Construction Division
Additions & Alteration Charges Approval Form

MAYFLOWER PLATINUM

Details of Additions & Alterations

Flat No	103	Block	'C'
Flat Area	1500 sft	Type	Deluxe / Luxury
Buyer Name	GADEPOKA BHASKAR VINAY		
Phone No.	8918486149	Email	Vin.Vinaygb@gmail.com.

ELECTRICAL PLAN OF FLAT-C3

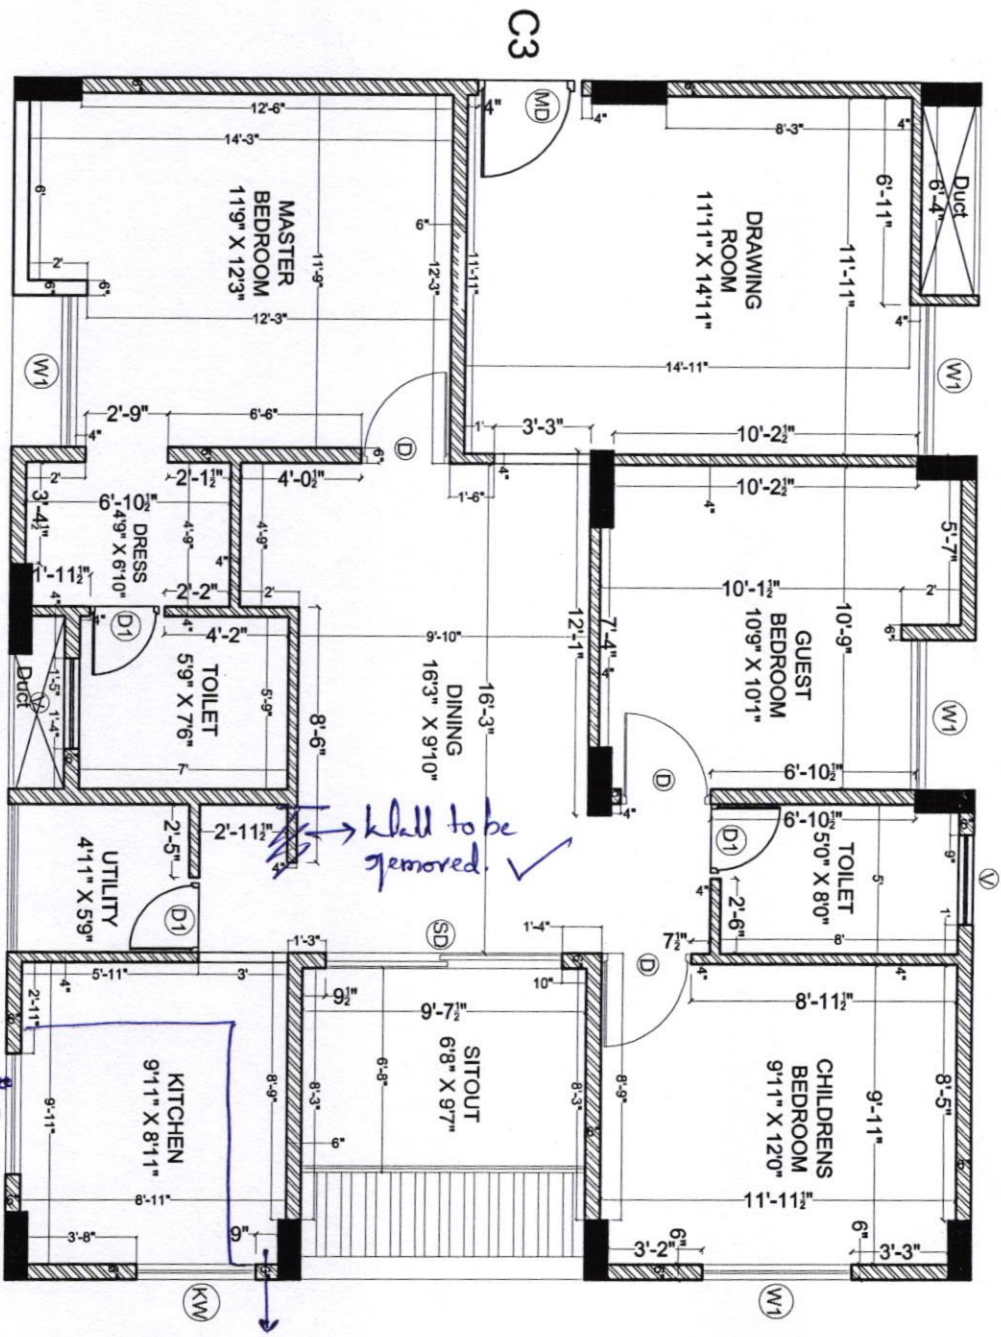
Changes in electrical points: (mark on plan)

- 1) Tr point to be given in CBR as marked.
- 2) Every room with internet connection to be given. Ep Tublight to be given.
- 3) SA point to dining to be shifted to opp wall.

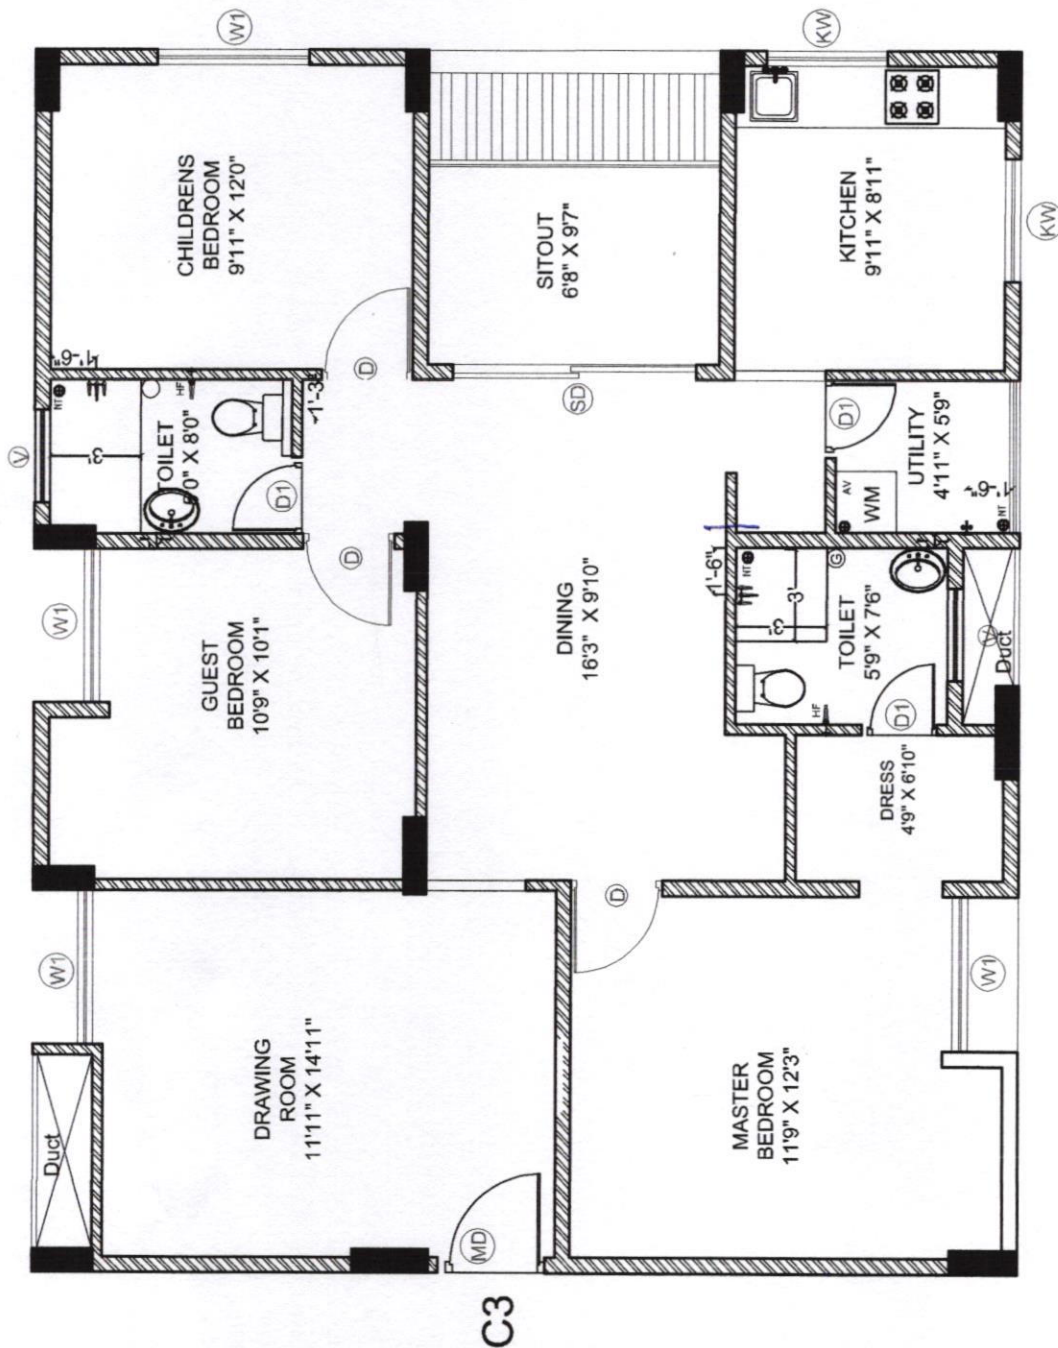
Other Changes:

- 1) Wall in dining area to be removed as marked.
- 2) 'L' Shape Left to be provided in kitchen.
